Final decision

**ElectraNet
transmission determination
2008–09 to 2012–13**

11 April 2008

Figure A.1: Contingent risk annual dollar consequence sensitivity test results

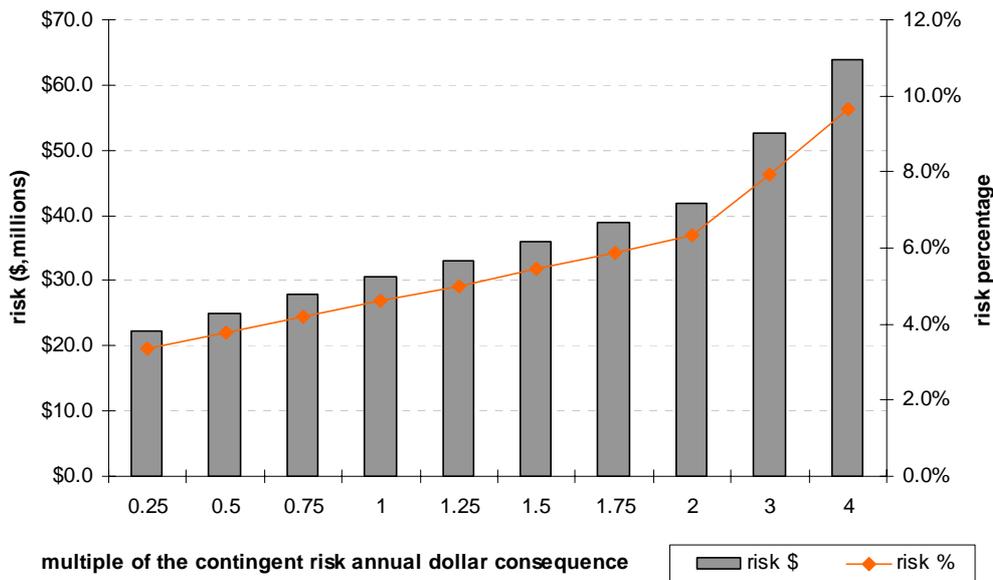
This is even more the case because the AER analysis indicated that the risk model is sensitive to the annual dollar value consequence assigned to each contingent risk element. Holding everything else constant, changing the annual dollar consequence for each contingent risk element (multiplying by various values to adjust the dollar consequences) resulted in significant changes to the overall risk factor, as shown in figure A.1. To be accepted as reasonable inputs to the model, these dollar consequences need to be verified. In the absence of this verification, the AER is not satisfied that ElectraNet has addressed concerns that the risk profiles are not based on past evidence of actual occurrences or actual cost impacts of the identified risk elements.

Although the inputs to the inherent risk category appear to display some moderating influences, given the weight of the other two risk categories (as shown in table A.1) and the sensitivity of the annual dollar consequences (as shown in figure A.1), the AER is not satisfied that ElectraNet has sufficiently demonstrated that the proposed risk factor has accounted for new initiatives and estimating procedures.

Figure A.2: Results of removing risk categories

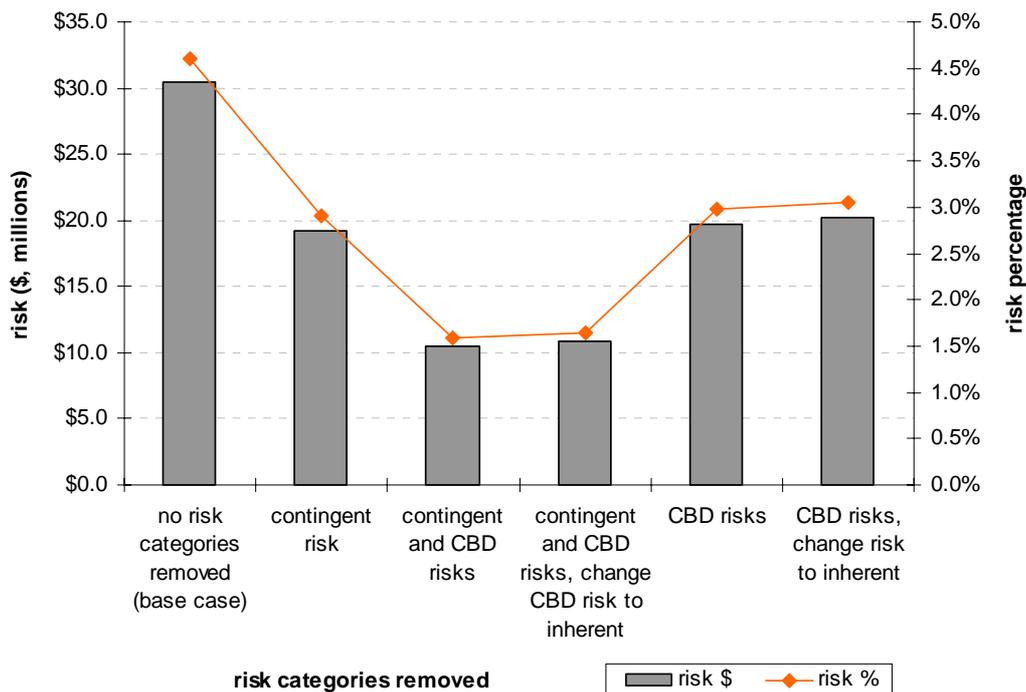
Figure A.2 shows that there is a significant change to the overall risk factor depending on the mix of risk categories used. For example, calculating the Adelaide CBD project risks using the inherent risk methodology rather than as a separate risk assessment causes the overall risk factor to drop to 3 per cent. The AER notes that EP's testing also showed a risk factor of only 2.9 per cent after removal of the contingent risk category.²⁴³

Figure A.3: Impact of size of capex portfolio on the risk factor

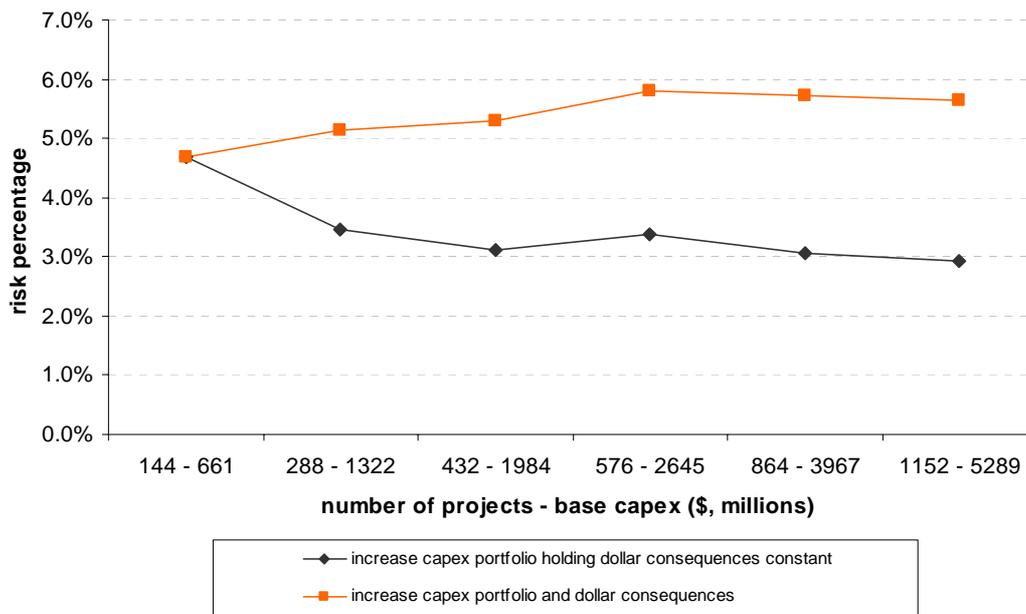
The AER’s test results as shown in figure A.3 indicate that where the capital program and dollar consequences are simultaneously increased by the same multiplier the risk factor increases over a larger program. In the context of ElectraNet’s risk model, the results indicate that the impact of the size of the capital program on the overall risk factor is sensitive to the underlying inputs to the model. From this, the AER cannot reasonably conclude that a larger project portfolio will necessarily have a lower risk factor.

Accordingly, the AER considers that the relationship between the size of the project portfolio and the risk factor is unclear, and therefore each TNSP’s proposed risk factor will be reviewed in the context of its risk model inputs and methodology.
